4 WAY COMBINER BD

THIS PRINT IS THE PROPERTY OF ITS CORP. IT SHALL NOT BE COPIED WITHOUT PERMISSION.				TITLE SCH, 4 WAY COMBINER BD (1227-1311)			
MATERIAL -----		DWN SJM 2/16/94		DWG. NO. 1227-3311		REV 1	
FINISH -----		CHK DWB 2/17/94		REL DWB 2/17/94		SCALE ----	
REV ECN		DATE APV		SHEET 1 OF 1

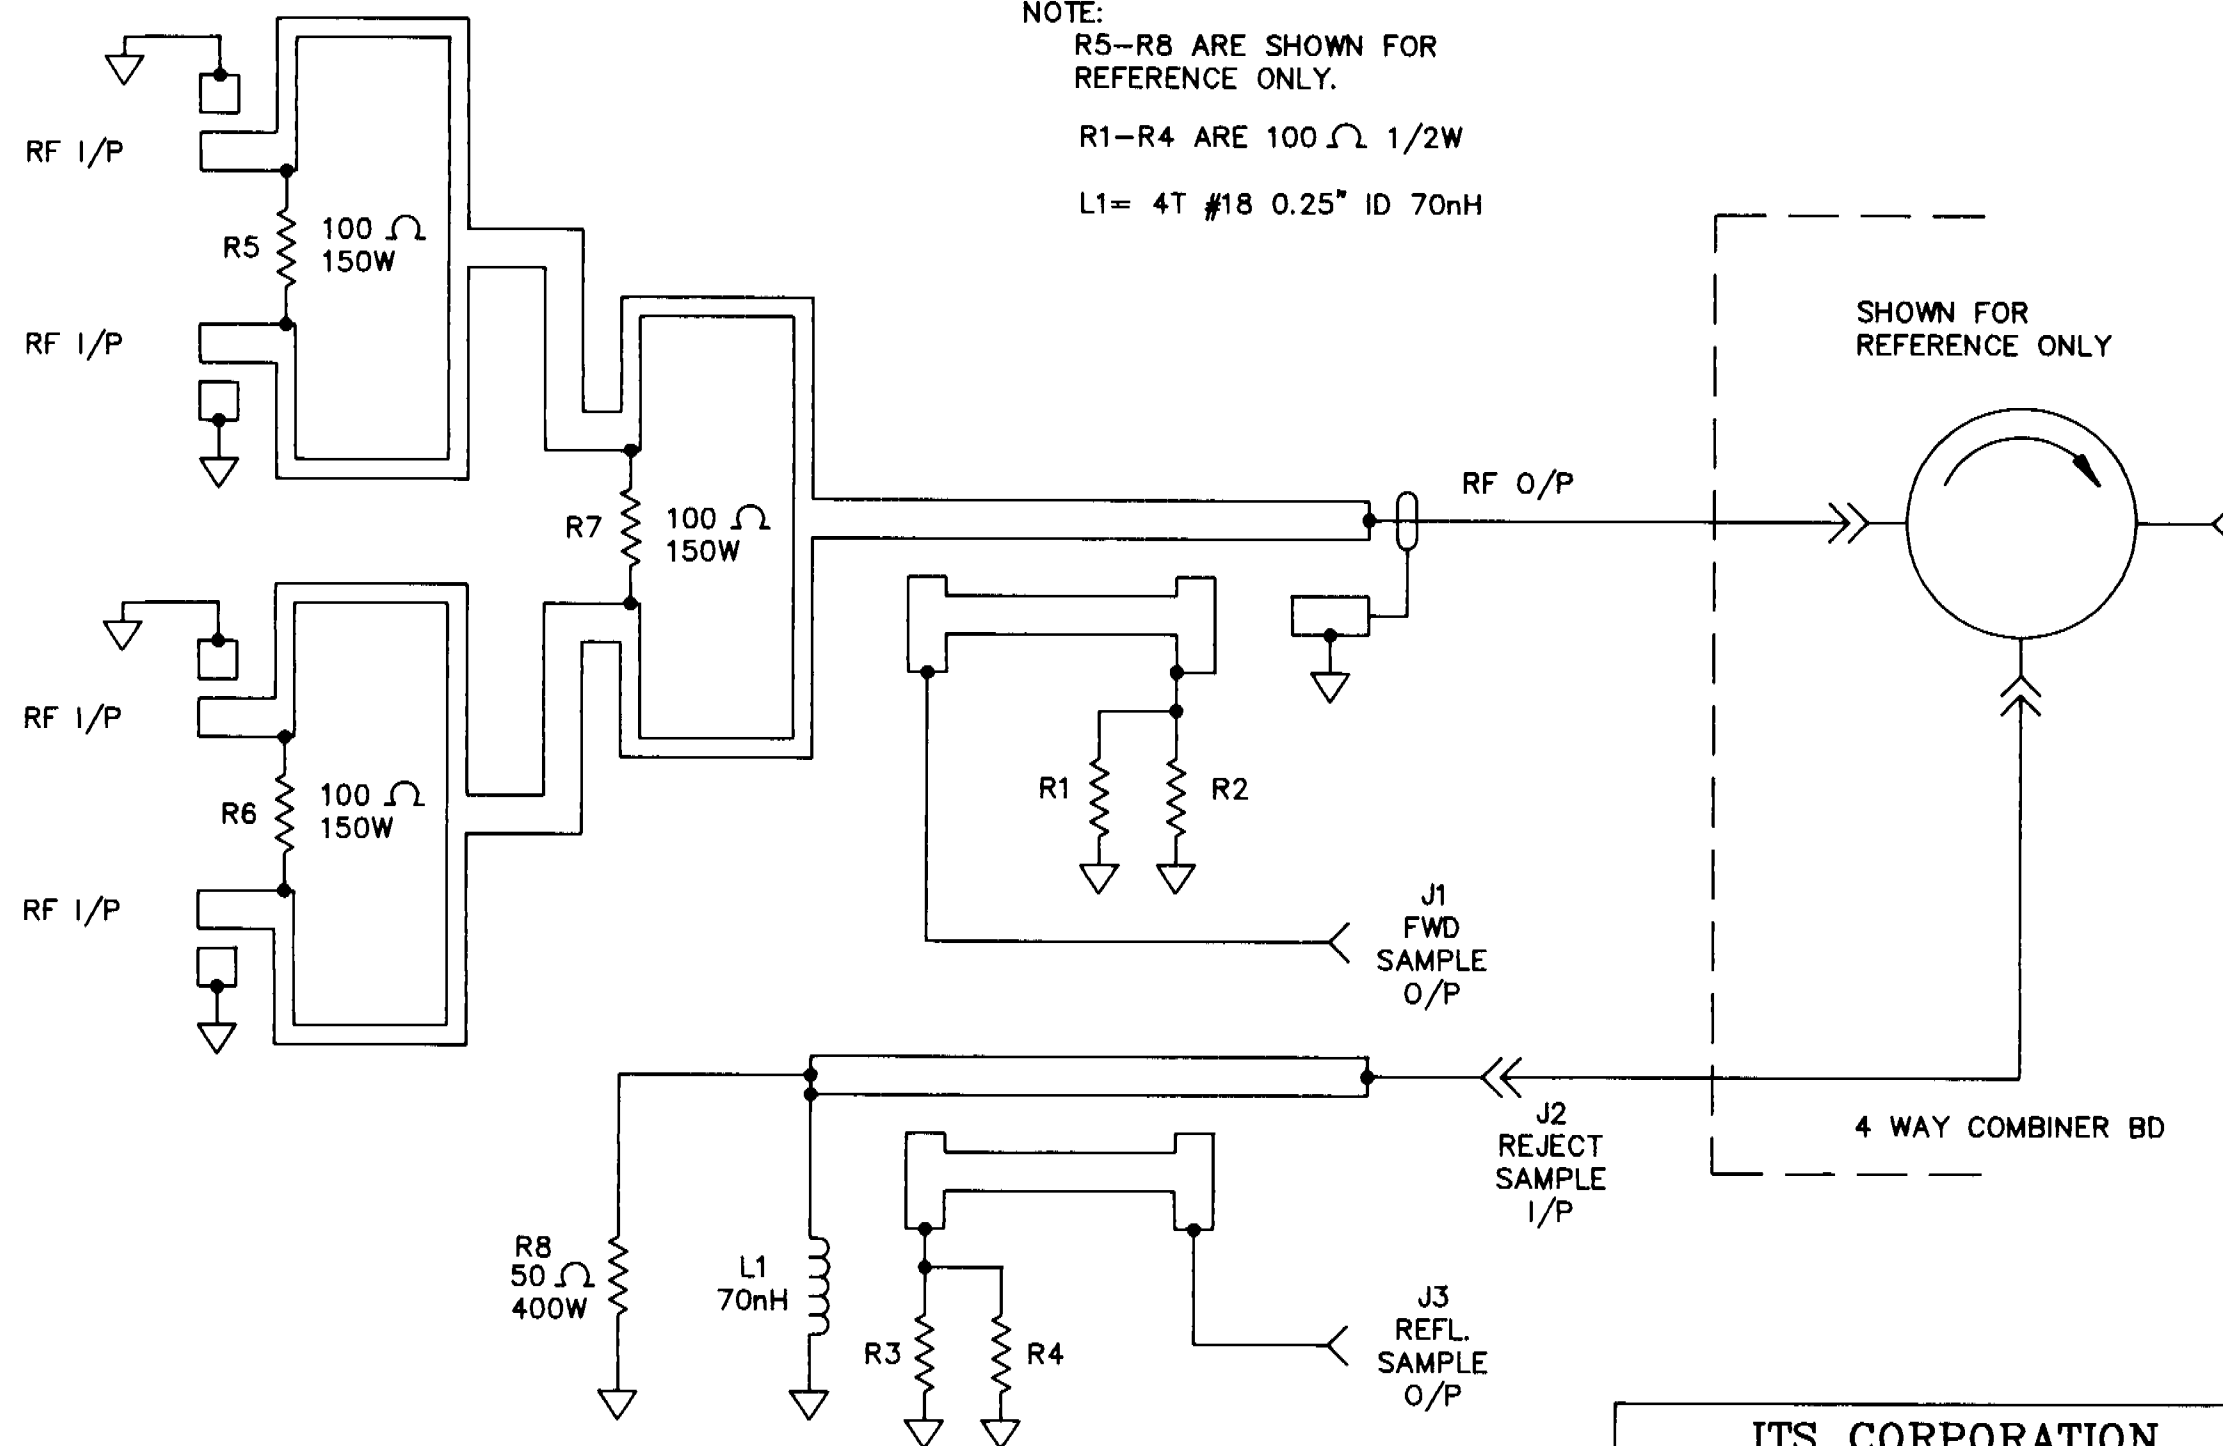
CHANGED R5, R6 AND R7
 250W TO 150W. ADDED 70nH
 TO L1, ALSO ADDED LABELING
 TO J1, J2 AND J3. (RFB)
